Contract #: 04-0120F4Cty: SF/ALA Rte: 80 PM: 13.2/13.9File #: 69.25B**QUALITY ASSURANCE -- NON-CONFORMANCE REPORT****Location:** Changxing Island, Shanghai, P.R. China**Report No:** NCR-000421**Prime Contractor:** American Bridge/Fluor Enterprises, a JV**Date:** 24-Aug-2009**Submitting Contractor:** Zhenhua Port Machinery Company, Ltd (ZPMC), Changxing Island**NCR #:** ZPMC-0395**Type of problem:**

Reference Description: Missed MT Indications by QC on Stiffeners to Side Panel Weld Joints**Description of Non-Conformance:**

Job Name: SAS Superstructure

Subject: NCR No. ZPMC-0395

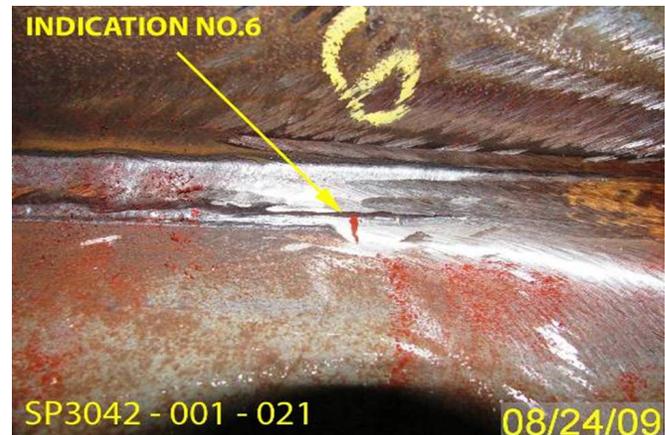
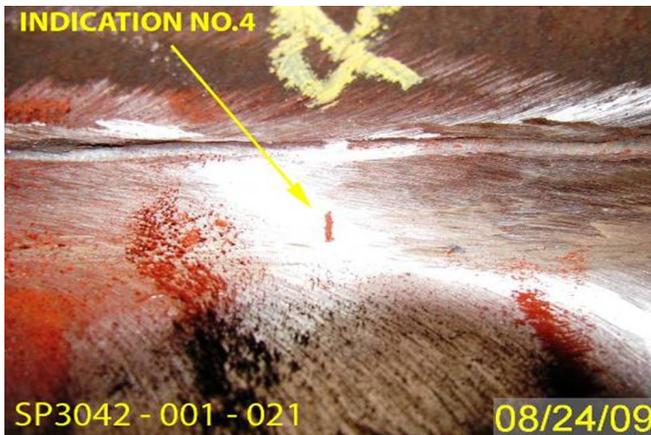
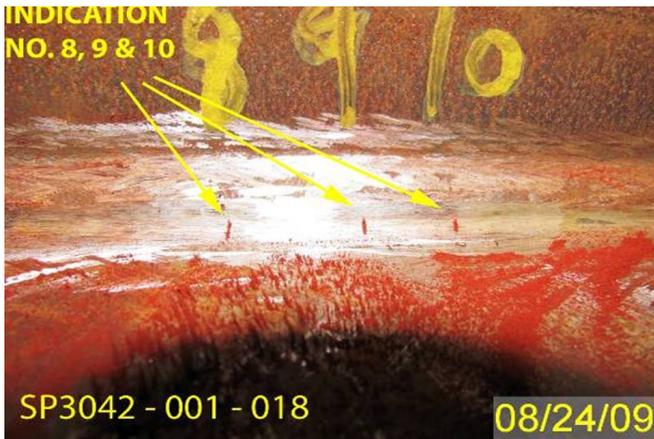
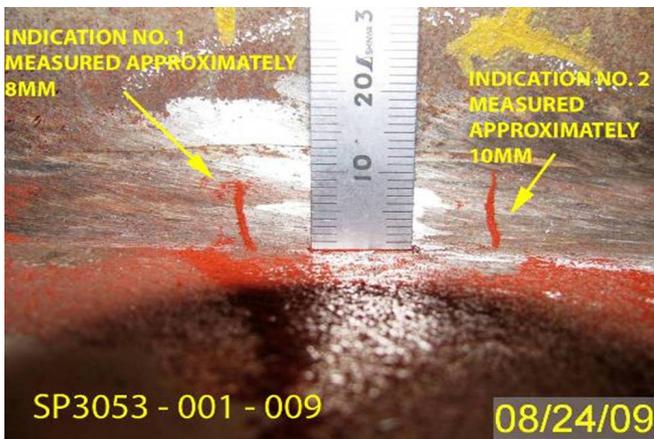
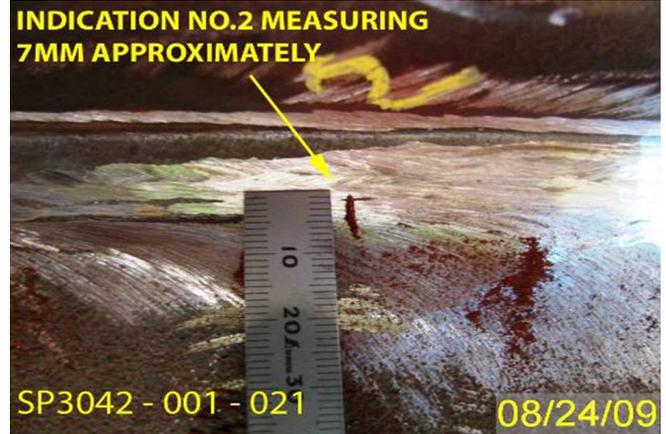
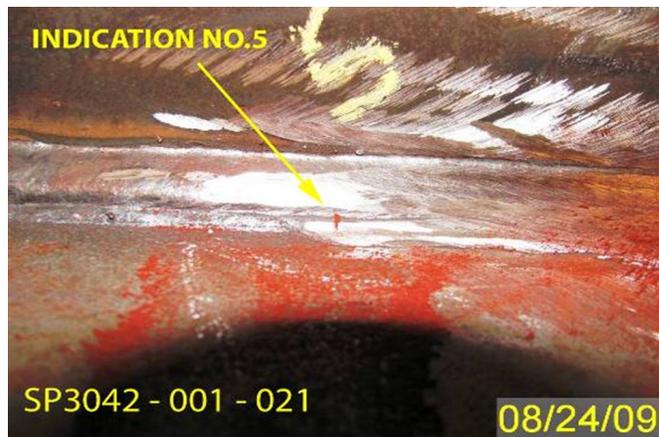
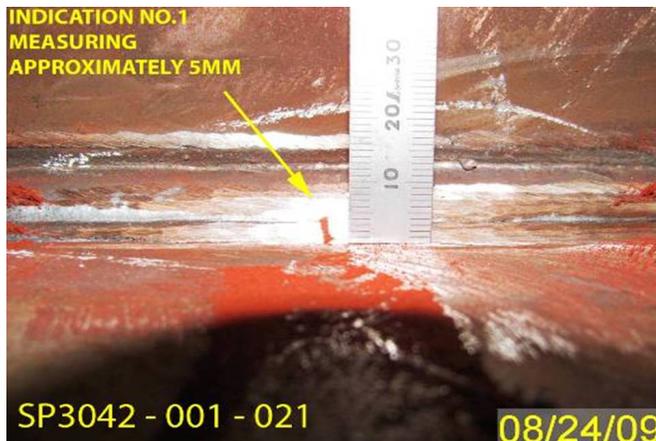
Caltrans Quality Assurance (QA) Inspector was provided an inspection request for Magnetic Particle Testing (MT) of the OBG Side Plates located in Bay #6. This Caltrans Quality Assurance (QA) Inspector observed a total of Twelve (12) transverse linear indications. The indication lengths measured approximately 4mm to 10mm in length. The Side Plates are identified as SP3042-001 (12CW) and SP3053-001 (12BW).

The affected weld designations are as follows:

SP3042-001-021 - Six (6) Transverse linear indications

SP3042-001-019 - One (1) Transverse linear indication

SP3042-001-018 - Three (3) Transverse linear indications

SP3053-001-009 - Two (2) Transverse linear indications

The above mentioned Side Plates had been welded on the gantry with automatic FCAW by electrode Super cored 71H (1.4 diameter) (E71T-1) using WPS-B-T-2132-3. These welds had been previously tested and accepted by ZPMC NDT personnel.

Submit a repair procedure to the engineer for approval.

项目名称 Project Name:	美国海湾大桥 SFOBB	部件图号 Drawing No.:	SP3042A	报告编号 Report No.:	B-CWR938
合同号 Contract No.:	04-0120F4	部件名称 Item Name:	OBG SIDE PLATE 12C-E8	NDT 报告编号 NDT Report No.:	B787-MT-16172
项目编号 Project No.:	ZP06-787

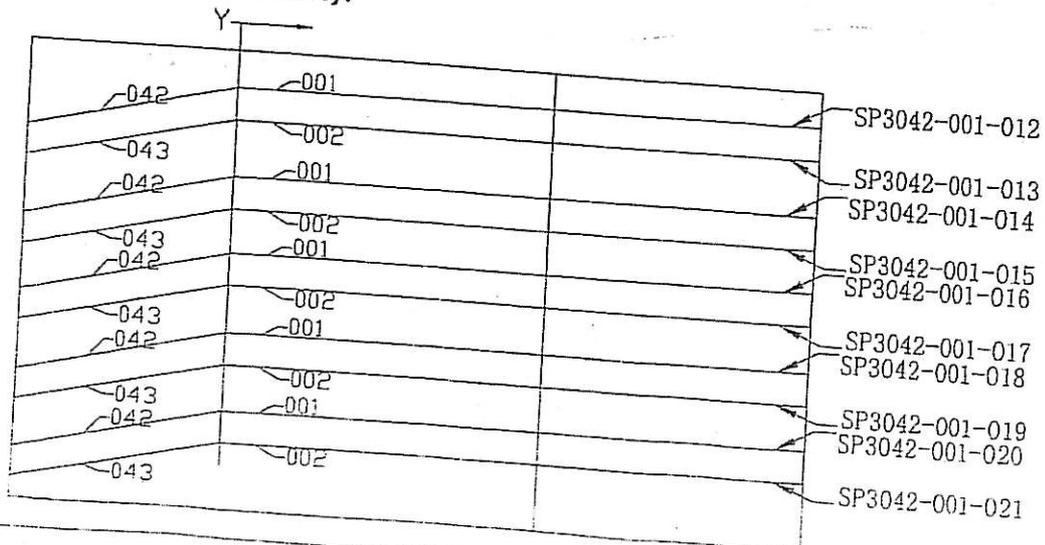
One transverse crack was found by use of MT on SP3042-001-001.
 One transverse crack was found by use of MT on SP3042-001-008.
 Two transverse cracks were found by use of MT on SP3042-001-009.
 Two transverse cracks were found by use of MT on SP3042-001-012.
 One transverse crack was found by use of MT on SP3042-001-013.
 Two transverse cracks were found by use of MT on SP3042-001-015.
 Six transverse cracks were found by use of MT on SP3042-001-017.
 Two transverse cracks were found by use of MT on SP3042-001-018.
 Five transverse cracks were found by use of MT on SP3042-001-019.
 Seven transverse cracks were found by use of MT on SP3042-001-021.

All cracks were extended to material.
 Please see the detail data from MT report!

- 1. 火焰加热时, 水汽没有完全的去掉或者这个区域预热不够;
- 1. Moisture wasn't completely removed during drying operation (preheating) or the area wasn't preheated sufficiently.

- 1. QC and a Lead CWI shall be present, direct and supervise all grinding and welding operations during this repair to ensure the repair is per the disposition requirements

- 2. QC and a Lead CWI shall have an approved copy of the CWR in hand prior to the repair.
- 3. Remove paint ≥ 25 mm in all direction of HAZ prior to MT.

- 4. Clean the excavation area of all loose debris including MT powder. Preheat to 65° C before removing cracks by grinding, repair area shall extend a minimum of 50mm beyond each end of single crack repairs, and 50mm beyond the outermost cracks for multiple crack repairs.

- 5. If base metal is damaged by grinding, the damaged area shall be ground clean prior to performing weld repair. If gap > 5 mm is found during or after grinding, comply with the notification on changing fillet weld to CJP which is submitted for Engineer's review and approval form.

- 6. Prepare excavation in accordance with the New Repair Procedure prior to welding.
- 7. Before this repair, Verify with VT and MT repair areas are defects free, and also MT shall be performed on the base metal along cracks to ensure that no cracks were propagated to the base metal. Separate CWR approval is needed if cracks are found in the base metal and only after this new CWR's approval can continue the repair. *CRACKS EXIST IN B.M., DO NOT ENTIRE EXCAVATION AREA PRIOR TO WELDING.*

- 8. Clean excavation area of all loose debris including MT powder after excavation. Preheat and weld according to repair WPS, the preheat shall between 160° C-230° C.

- 9. Perform post weld heating according to repair WPS, the postheat shall between 230° C-315° C and for one hour minimum.
- 10. Allow the weld to cool to ambient temperature gradually. Control cooling rate after PWHT to no more than 50° C per hour.

- 11. Grind the repaired area flush with base metal or the adjacent weld after post weld heating.
- 12. Wait 48 hours at least after the repair area has cooled to ambient temperature before performing NDT.

- 13. Perform MT inspection to all repair area according to Contract Drawings along with all additional NDT required by the applicable notes Special Provision Section 10-1.59 'Steel Structure', subsection 'inspection testing'. NDT include VT, MT and UT if it is a CJP weld.

项目名称 Project Name:	美国海湾大桥 SFOBB	部件图号 Drawing No.:	SP3053A	报告编号 Report No.:	E-CWR895
合同号 Contract No.:	04-0120F4	部件名称 Item Name:	OBG SIDE PLATE 12 B-C4	NDT 报告编号 NDT Report No.:	B787-MT-15371
项目编号 Project No.:	ZP06-787

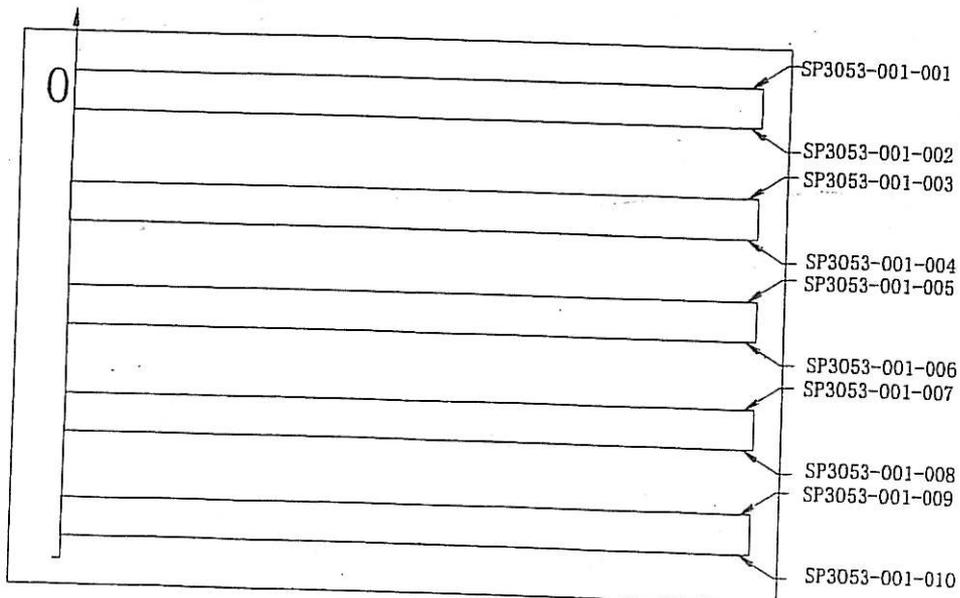
Six transverse cracks were found by use of MT on SP3053-001-004.
 Four transverse cracks were found by use of MT on SP3053-001-006.
 Four transverse cracks were found by use of MT on SP3053-001-007.
 One transverse crack was found by use of MT on SP3053-001-008.
 One transverse crack was found by use of MT on SP3053-001-009.
 Three transverse cracks were found by use of MT on SP3053-001-010.

Please see the detail data from MT report!

1. 火焰加热时, 水汽没有完全的去掉或者这个区域预热不够;
1. Moisture wasn't completely removed during drying operation (preheating) or the area wasn't preheated sufficiently.

1. QC and a Lead CWI shall be present, direct and supervise all grinding and welding operations during this repair to ensure the repair is per the disposition requirements

2. QC and a Lead CWI shall have an approved copy of the CWR in hand prior to the repair.
3. Remove paint $\geq 25\text{mm}$ in all direction of HAZ prior to MT.

4. Clean the excavation area of all loose debris including MT powder. Preheat to 65° C before removing cracks by grinding, repair area shall extend a minimum of 50mm beyond each end of single crack repairs, and 50mm beyond the outermost cracks for multiple crack repairs.

5. If base metal is damaged by grinding, the damaged area shall be ground clean prior to performing weld repair. If gap $> 5\text{mm}$ is found during or after grinding, comply with the notification on changing fillet weld to CJP which is submitted for Engineer's review and approval form.

6. Prepare excavation in accordance with the New Repair Procedure prior to welding.
7. Before this repair, Verify with VT and MT repair areas are defects free, and also MT shall be performed on the base metal laying abroad cracks to ensure that no cracks were propagated to the base metal. Separate CWR approval is needed if cracks are found in the base metal, and only after this new CWR's approval can continue the repair.

8. Clean excavation area of all loose debris including MT powder after excavation. Preheat and weld according to repair WPS, the minimum preheat shall between 160° C-230° C.

9. Perform post weld heating according to repair WPS, the postheat shall between 230° C-315° C and for one hour minimum.
10. Allow the weld to cool to ambient temperature gradually. Control cooling rate after PWHT to no more than 50° C per hour.

11. Grind the repaired area flush with base metal or the adjacent weld after post weld heating.
12. Wait 48 hours at least after the repair area has cooled to ambient temperature before performing NDT.

13. Perform MT inspection to all repair area according to Contract Drawings along with all additional NDT required by the applicable notes Special Provision Section 10-1.59 'Steel Structure', subsection 'inspect on testing'. NDT include VT, MT and UT if it is a CJP weld.
